**Form for Comments**  
**Instrumentation and Control and Software Important to Safety for Research Reactors (DS436)**

Comments by reviewer				Resolution			
Reviewer:		Page of					
Country/Organisation: Australia		Date:					
Comment No.	Para/ Line No.	Proposed new text	Reason	Accepted	Accepted, but modified as follows	Rejected	Reason for modification/ rejection

**Applicability of DS436 recommendations on Research reactors  
I&C to other nuclear installations**

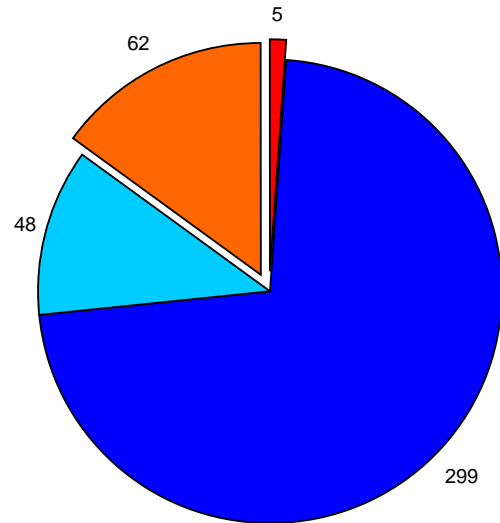
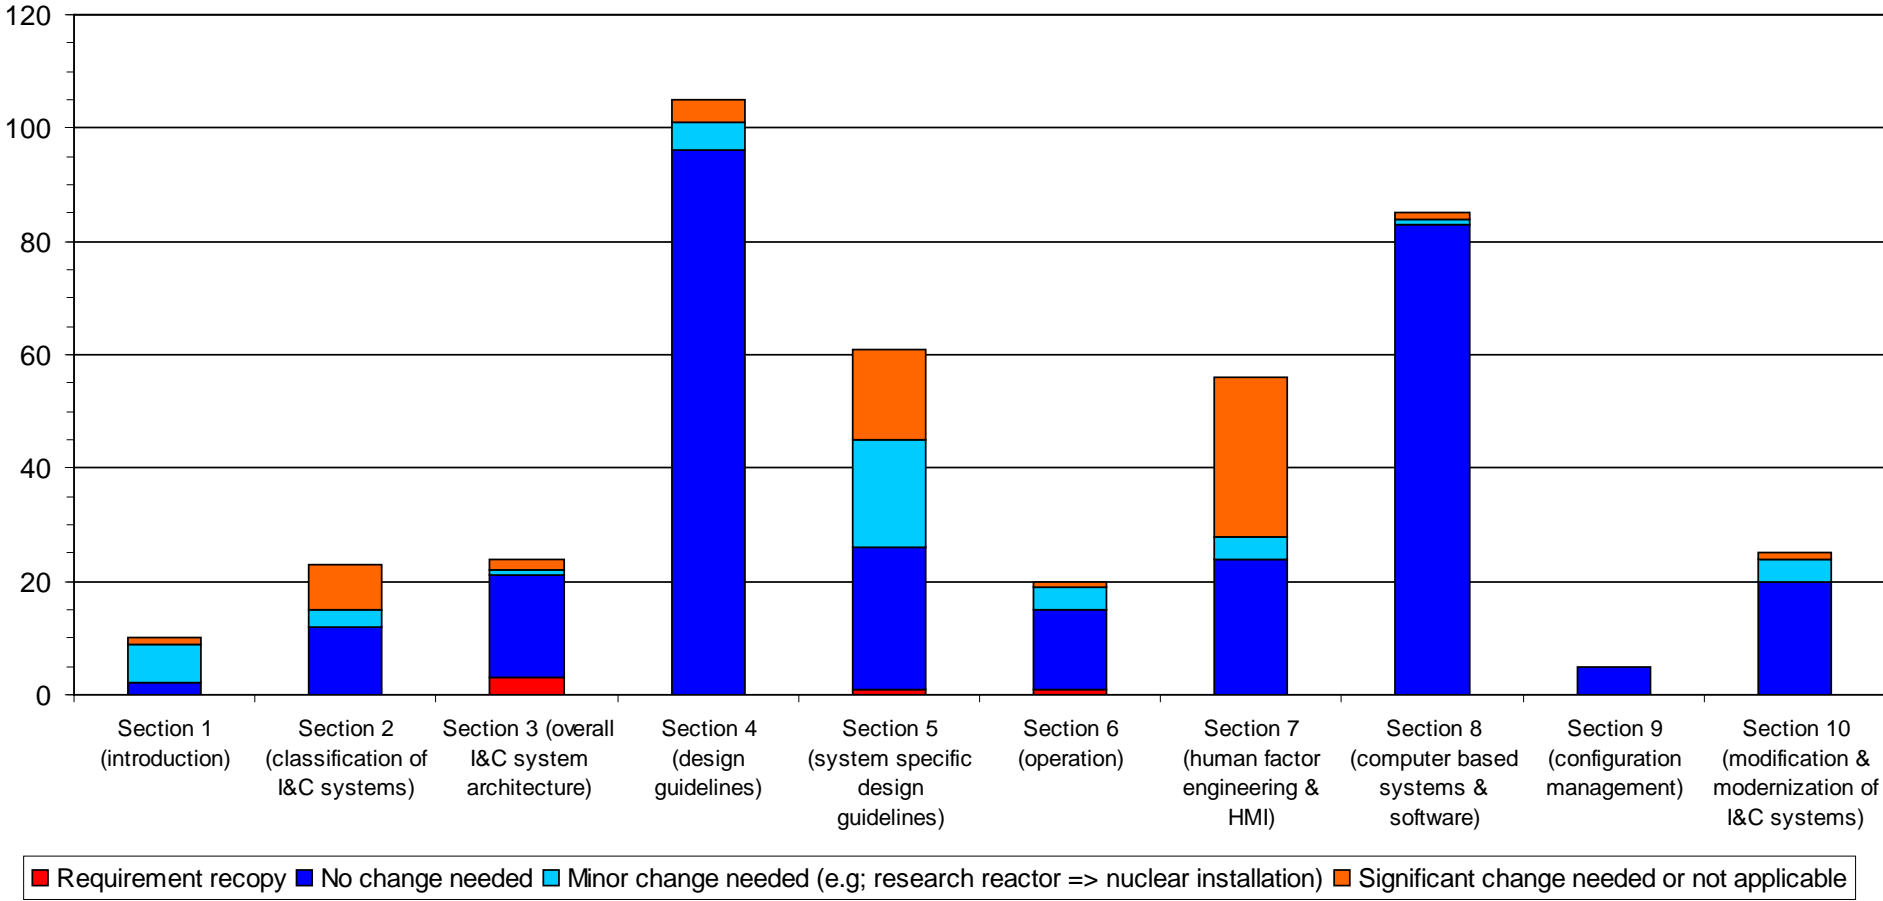
- Requirement recopy
- No change needed
- Minor change needed (e.g; research reactor => nuclear installation)
- Significant change needed or not applicable
